ORIGINATION FORM

Proposed Revisions to a Standard Plans Index
(Please provide all information — Incomplete forms will be returned)

Index Number: 646-001
Sheet Number (s): 1 of 1
Index Title:
Aluminum Post and Pedestal Mounted
Pedestrian Detectors and Signals

NOTES:

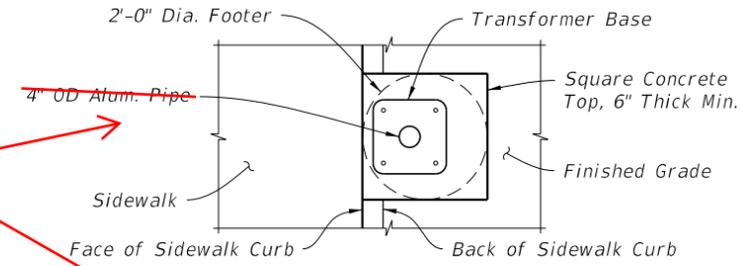
1. Work this Index with Specification 646.
2. For Pedestrian Signals see Index 653-001.
3. For Pedestrian Detector Assembly (i.e., Pushbutton and Sign) details see Index 665-001.
4. ~~Construct footing with Class I Concrete, footing may be Cast-In-Place (C-I-P) or Precast.~~

DELETE CLASS I REFERENCE IN NOTE 4

5. ADDED NOTE 5

- Changed Note 4 to remove concrete type since specified in Spec 646
- Added Note 5 "As an alternative to the direct buried "Post Mounted" Pedestrian Detector Assembly shown below, the post may be installed on a transformer base. Use a transformer base included on the APL approved as an alternative to a "Post Mounted" assembly."
- Updated the PEDESTAL MOUNTED detail - to show in the ADJACENT TO SIDEWALK detail "Tie Bars" callout as a #4 Stirrups equally spaced, with a 12" maximum spacing; Changed all references "4" Nominal Aluminum Pipe" , to Nominal 4" Aluminum Pole (Sch.40) (4.5" OD).
- Updated the POST MOUNTED detail - Changed the "4" OD Alum. Pipe" to "Nominal 4" Aluminum Post (Sch.40) (4.5" OD).

PLAN VIEW SECTION B-B

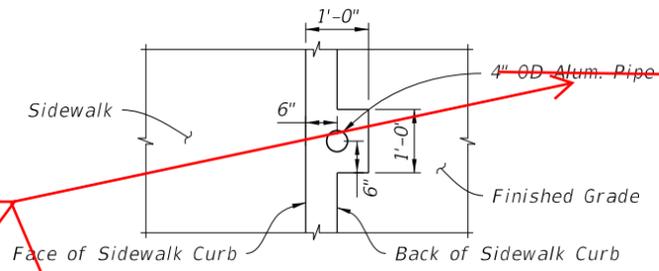
CHANGED TO: Nominal 4" Aluminum Pole (Sch. 40) (4.5" OD)

POST MOUNTED

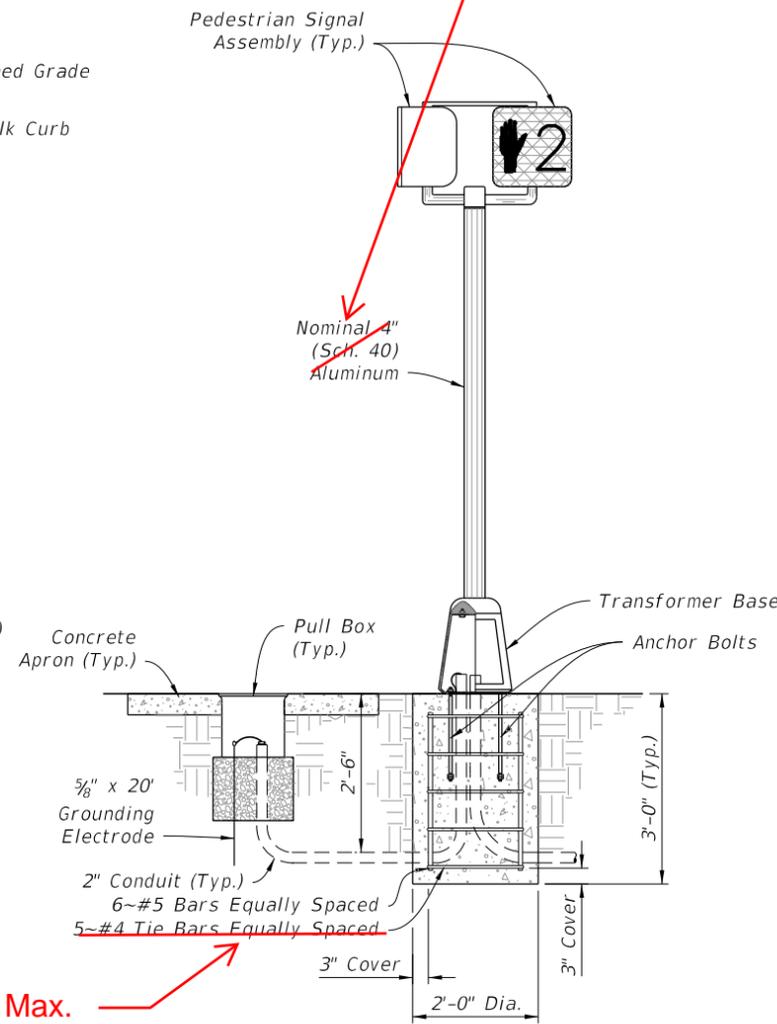
CHANGED TO: Nominal 4" Aluminum Post (Sch. 40) (4.5" OD)

CHANGED TO: #4 Stirrups Equally Spaced, 12" Max.

PEDESTAL MOUNTED

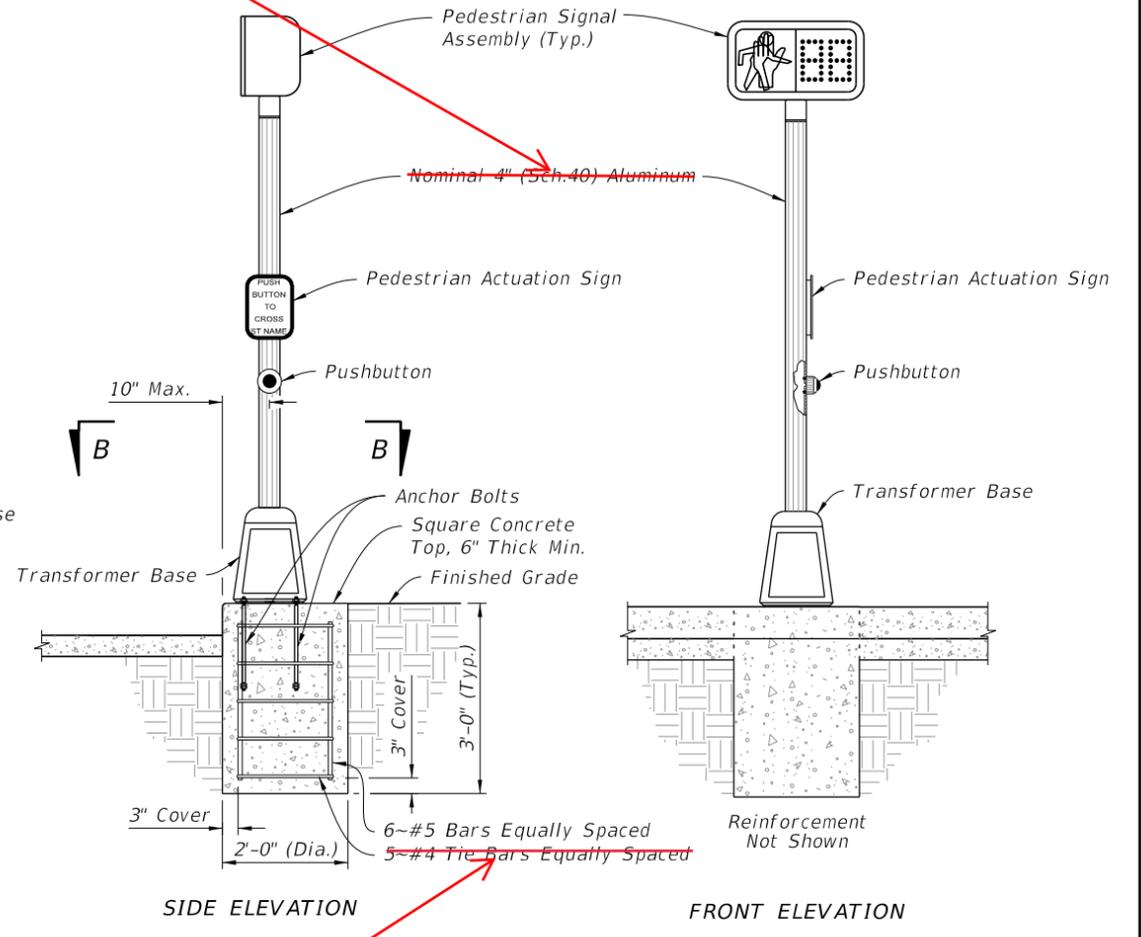
CHANGED TO: #4 Stirrups Equally Spaced, 12" Max.
